FIRST ADDENDUM

EIA for the Integrated Water Resource Management Project

AA. Ukulhas, Maldives

MODIFICATION TO PROPOSED FEEDWATER INTAKE

Intake and Brine Disposal Locations

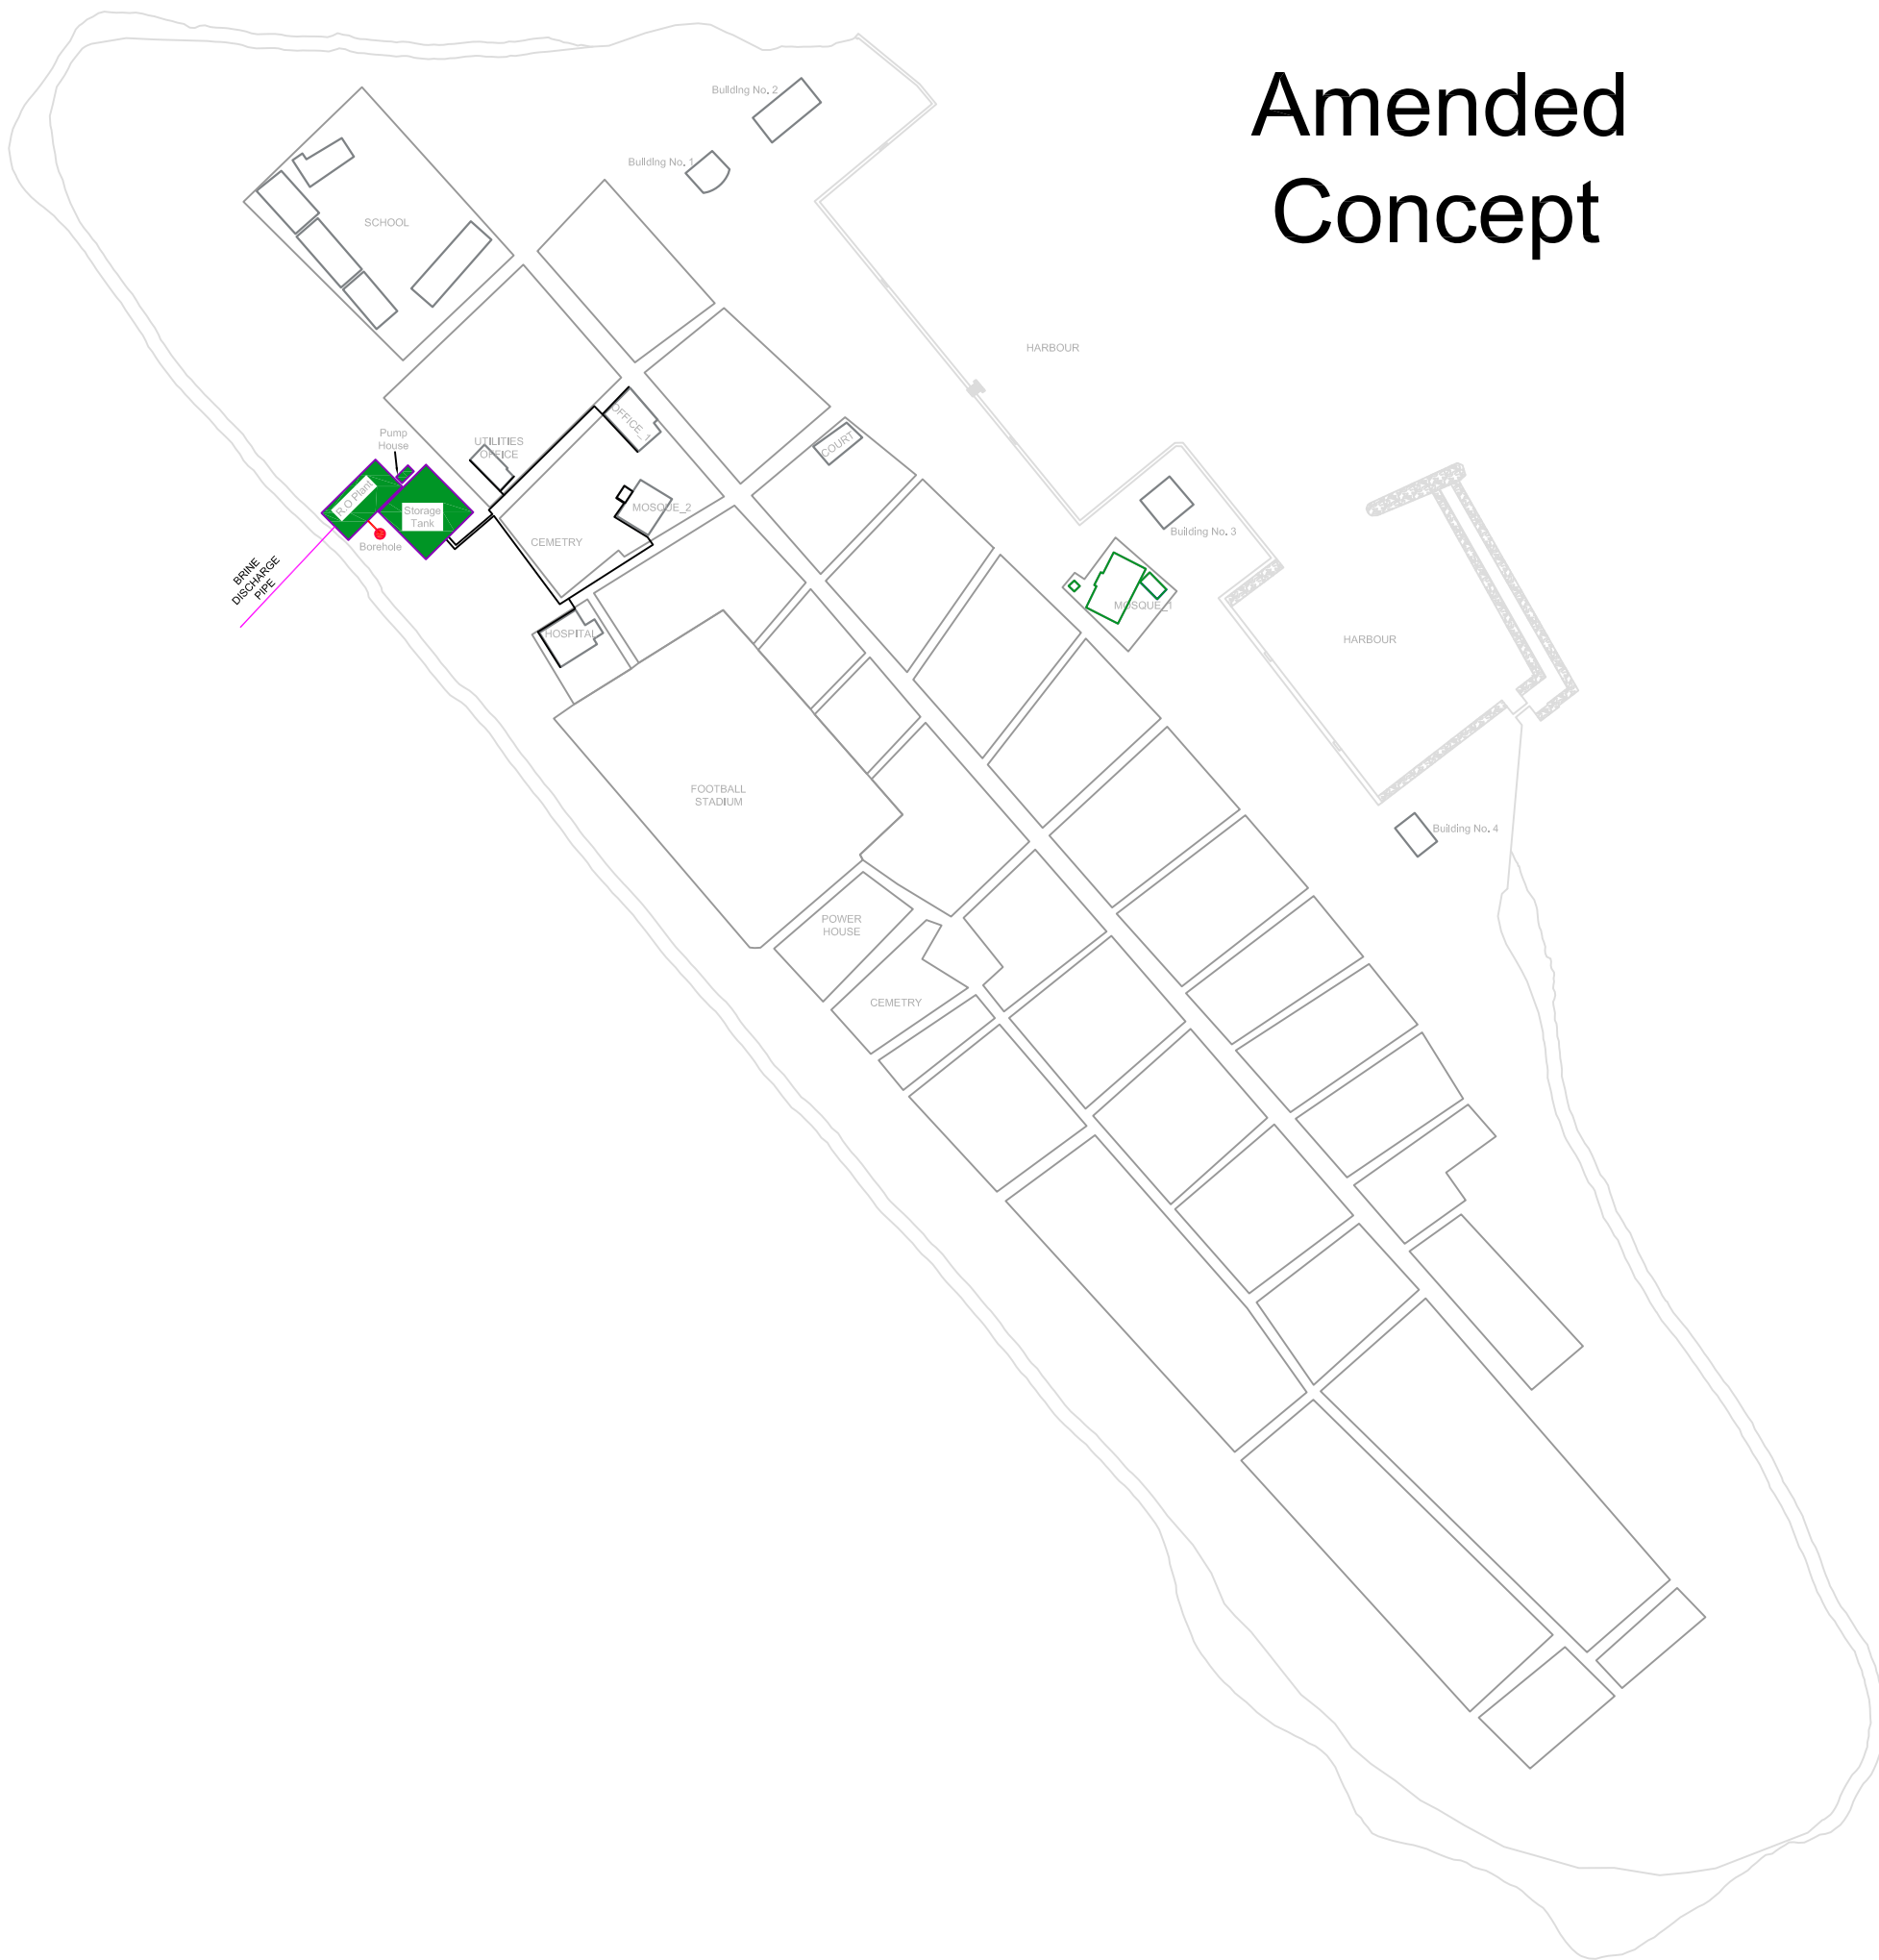
This is the first addendum to the Environmental Impact Assessment report prepared for the Integrated Water Resource Management Project, AA. Ukulhas, Maldives. This report is based on the scope identified by the EPA on 11 June 2014. The report covers the request to change the feed water intake from the lagoon to extracting water by boreholes there are disadvantages in taking water from the lagoon which is proposed in the EIA report. The location of the borehole is given in Figure 1.

The report covers the request to change the feed water intake from the lagoon to drawing water from one or more boreholes. There are disadvantages in taking water from the lagoon which is proposed in the EIA report. These two methods have been discussed below for their environmental, social and economic implications in order to understand the reasons for the proposed modification to the feedwater intake method.

In the Maldives, the Borehole Guidelines indicates that the borehole should be 30m below the ground and that the feed water shall have an electrical conductivity not less than 50,000uS/cm. Therefore, the proposed method is to draw water from a 30m-deep borehole.

Given assessment of the two options, the option of extracting water through bore holes is preferred over the lagoon intake due to decreased environmental impacts, more reliability to the operation of the RO plant, which is a major point as the service provided would be depended upon by the community of Ukulhas, and the sustainability of the project, where the use of boreholes are expected to increase the life span of the project.
